HISTORIC AND DESIGN REVIEW COMMISSION

HDRC CASE NO: 2019-100
ADDRESS: 306 E PARK AVE
310 E PARK AVE
LEGAL DESCRIPTION: NCB 392 BLK 30 LOT 2 & S 17.71 FT OF 1
NCB 392 BLK 30 LOT 3&4
ZONING: IDZ, IDZ,HS
CITY COUNCIL DIST.: 1
DISTRICT: Tobin Hill Historic District
APPLICANT: Patrick Christensen
OWNER: Imagine Built Homes LLC
TYPE OF WORK: Construction of eight townhomes
APPLICATION RECEIVED: March 29, 2019
60-DAY REVIEW: May 28, 2019
CASE MANAGER: Stephanie Phillips

REQUEST:

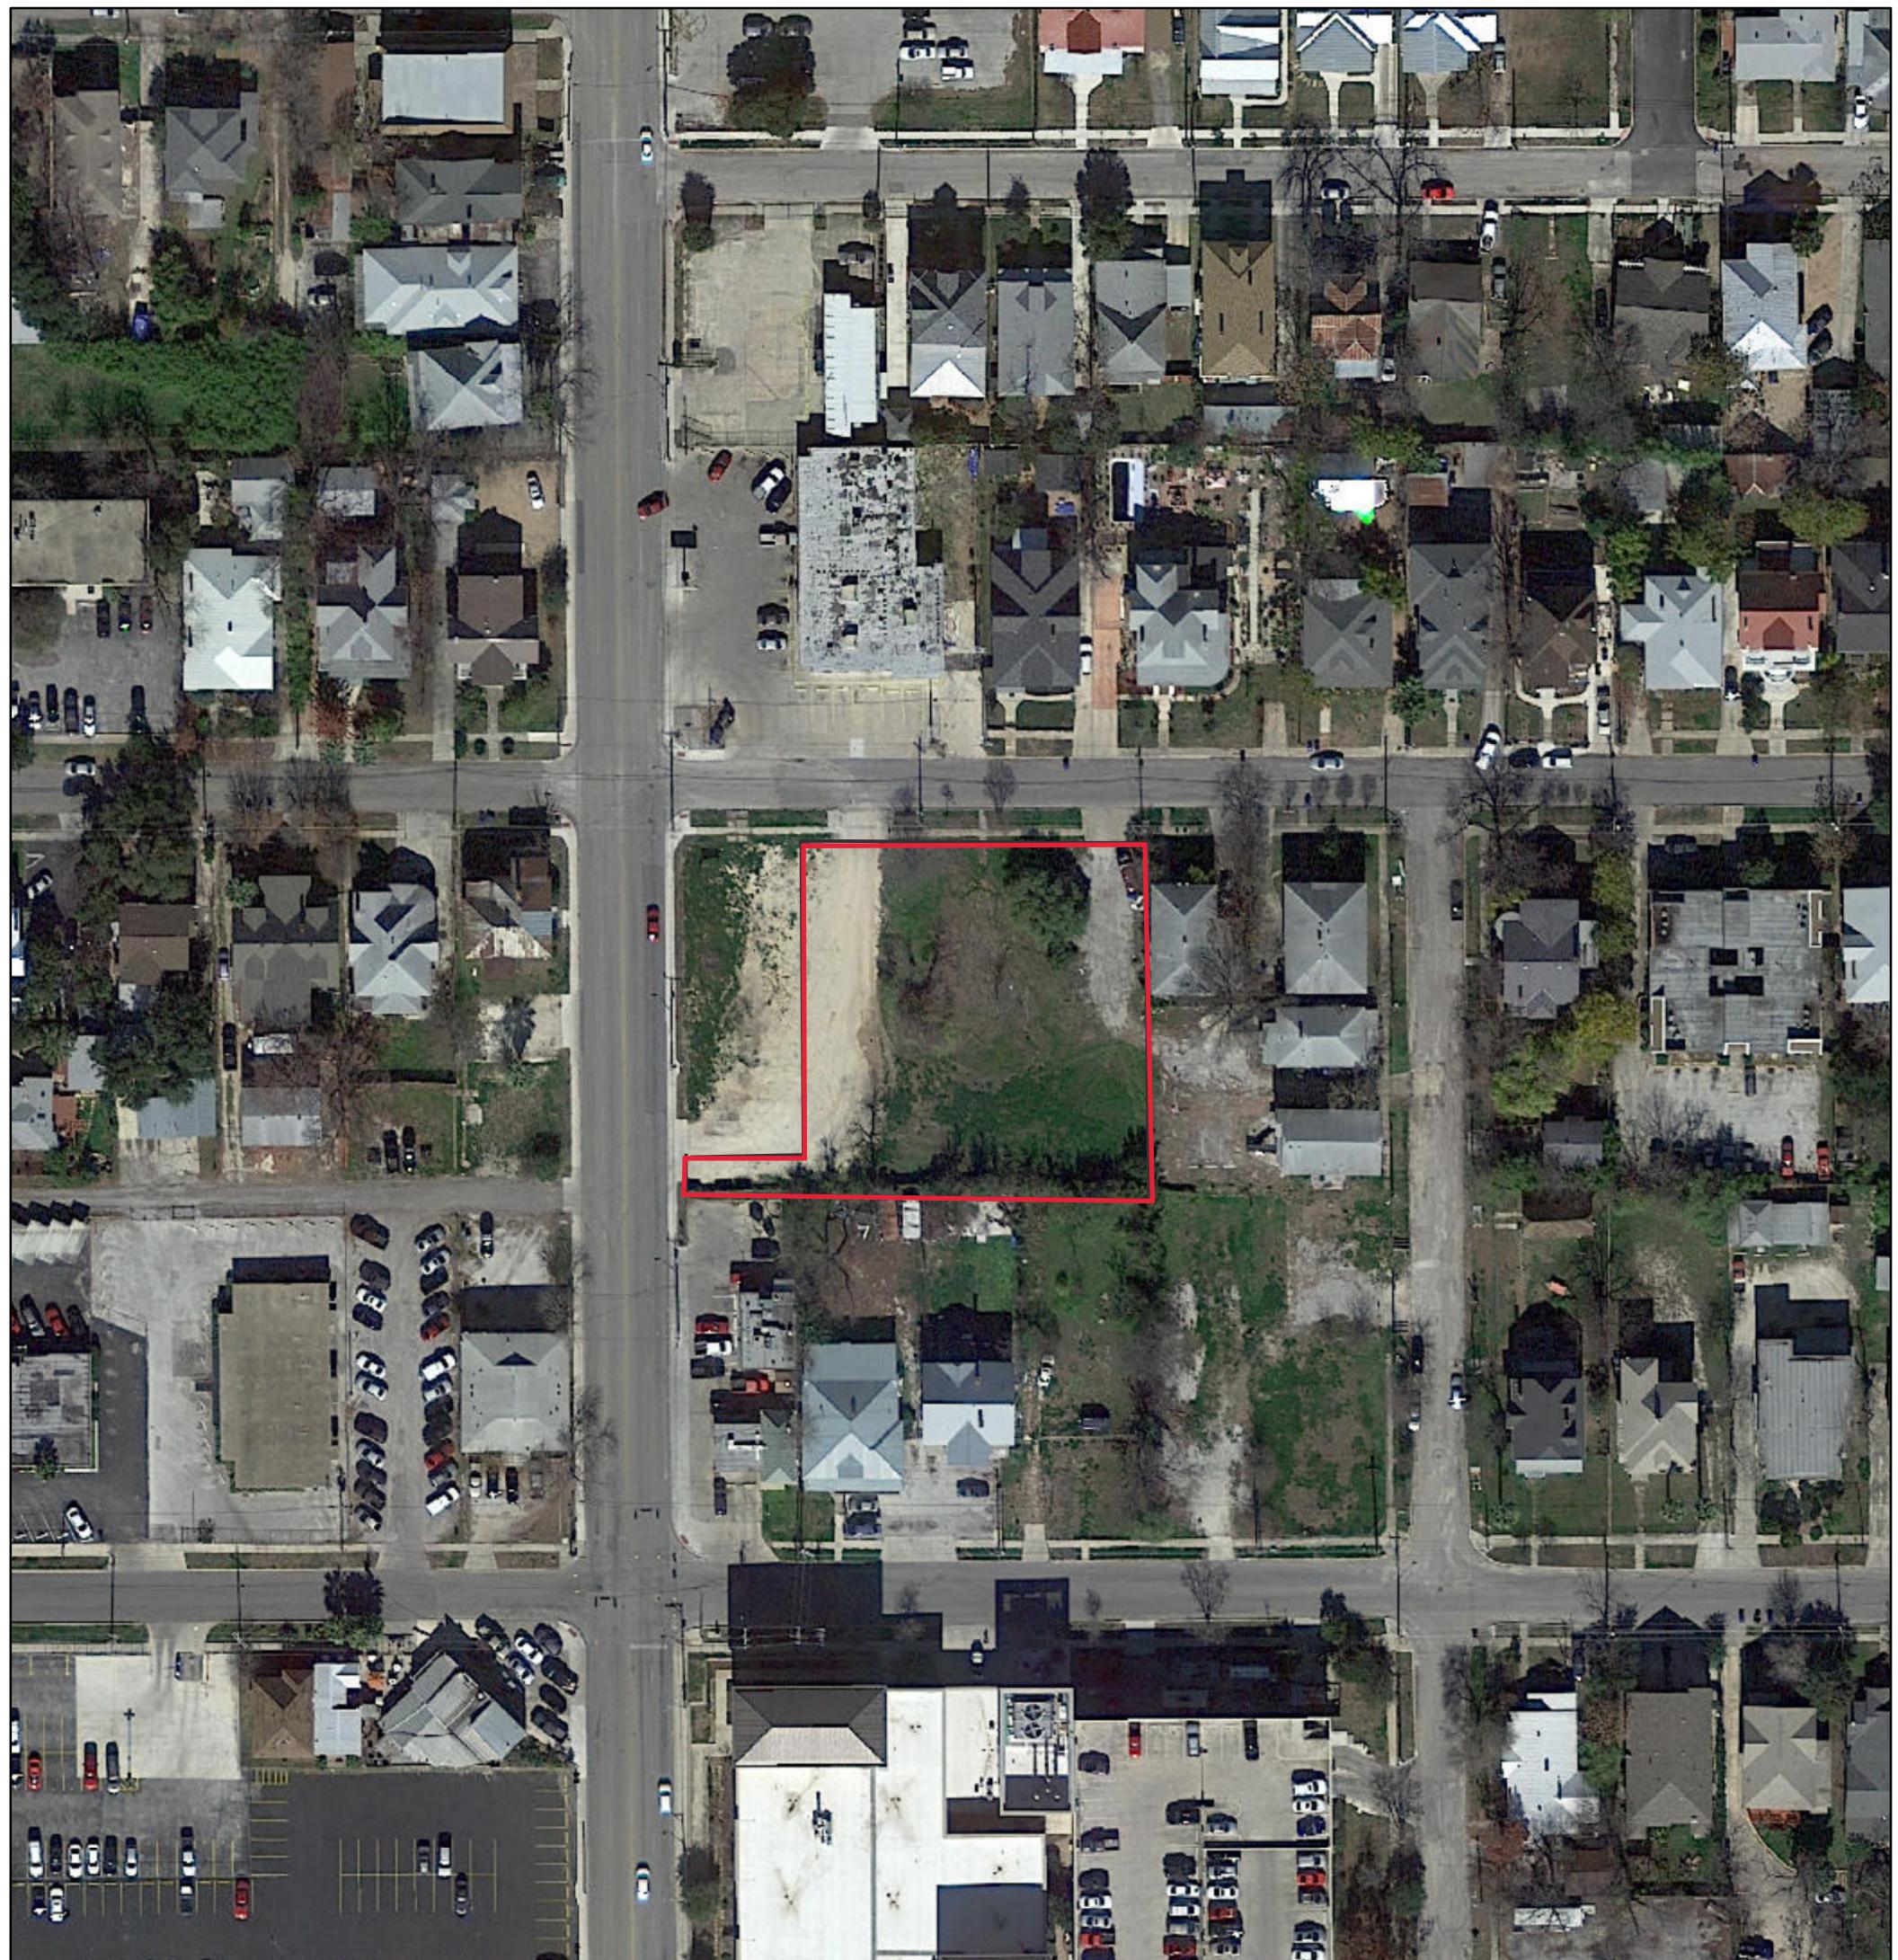
- p. HARDSCAPING – The applicant has proposed a 33'-4" wide central driveway property accessible off E Park.

The Guidelines state that driveway should be a maximum of 10 feet to comply with the historic development patterns of the district. Staff finds that the proposed parking pattern with a shared central drive deviates from the historic development pattern of the district, and finds that the proposed driveway width is inconsistent with the Guidelines.

- vii. That the applicant provides all exterior material specifications as noted in finding l.
- viii. That the applicant reduces the central driveway width as noted in finding q.

***E. PARK
NORTH ELEVATION***

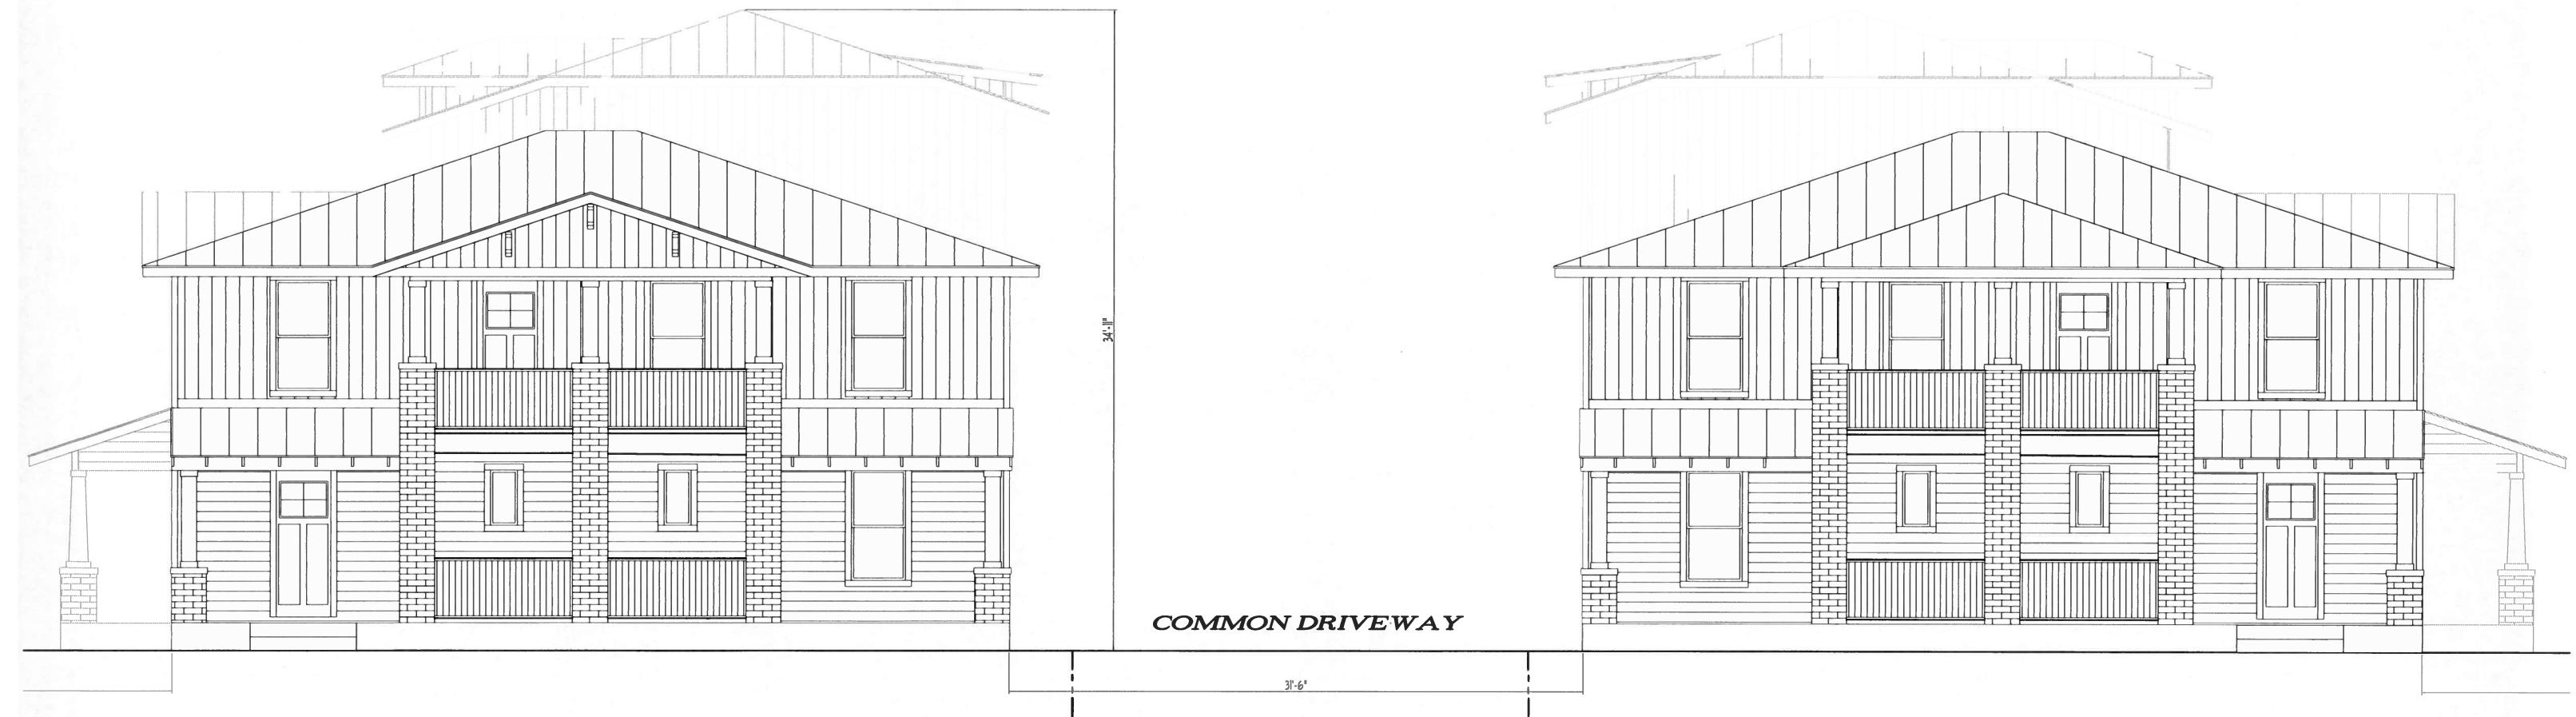
- f. SCALE & MASS – The applicant has proposed eight detached buildings within the district. Eight are three stories in height and the two closest to the street on E Park are two stories in height. The submitted elevations do not indicate a ridge height for any structure. Guideline 2.A.i stipulates that the height and scale of new construction should be consistent with nearby historic buildings and should not exceed that of the majority of historic buildings

by more than one-story. Staff finds that the overall height should be lowered to be more consistent with the Guidelines. Additionally, staff finds that the front two buildings facing Park Ave feature a façade width that is uncommon in the Tobin Hill Historic District. The proposed structures are wider than the adjacent two story historic houses on the block, which also feature full width front porches, generally symmetrical facades, and a consistent relationship of solids to voids. Staff finds that the massing of the front buildings should be modified to be more consistent with the Guidelines and the historic precedents on the block.

- ii. That the applicant reduces the width of the two front buildings facing Park Ave and incorporates more consistent architectural features, including proportionate porch elements and a consistent solid to void relationship, to be more consistent with massing precedents in the district as noted in finding g.
